Amendments to the Drawings:

REMARKS

FIG. 6

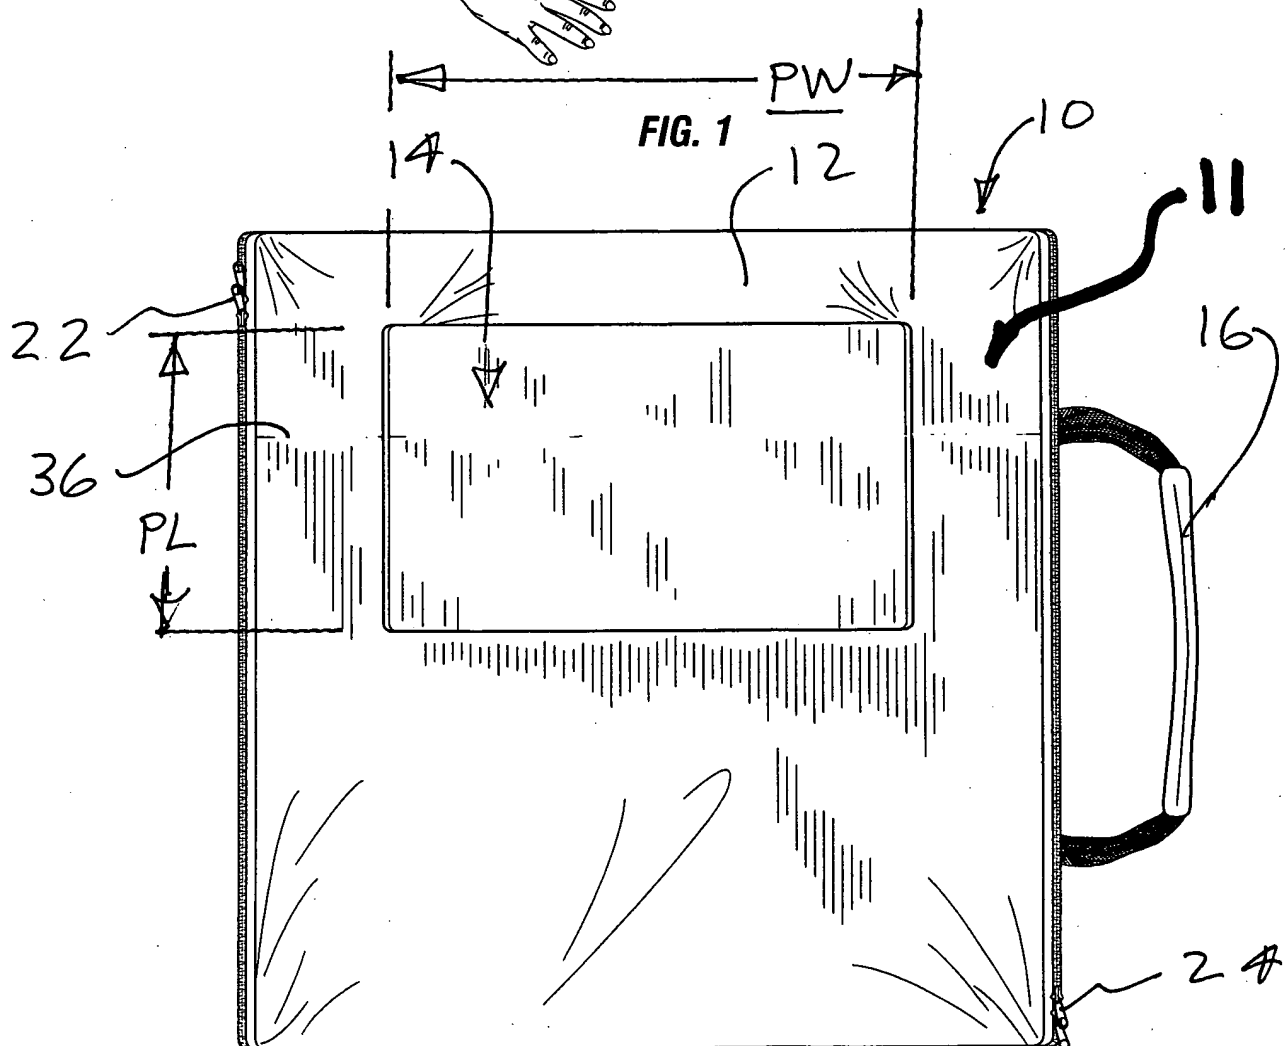
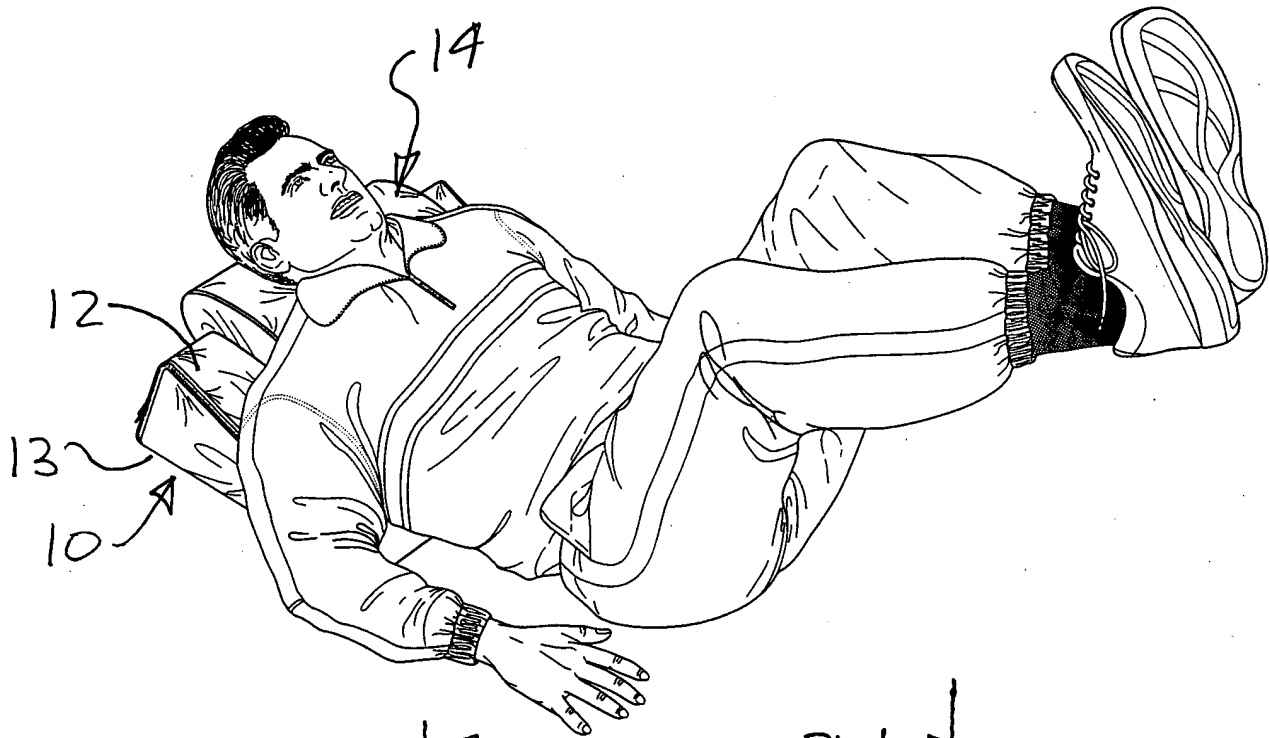
The attached sheet of drawings includes changes to Fig. 6. In Fig. 6, the previously omitted element number 11 has been added, along with a lead line.
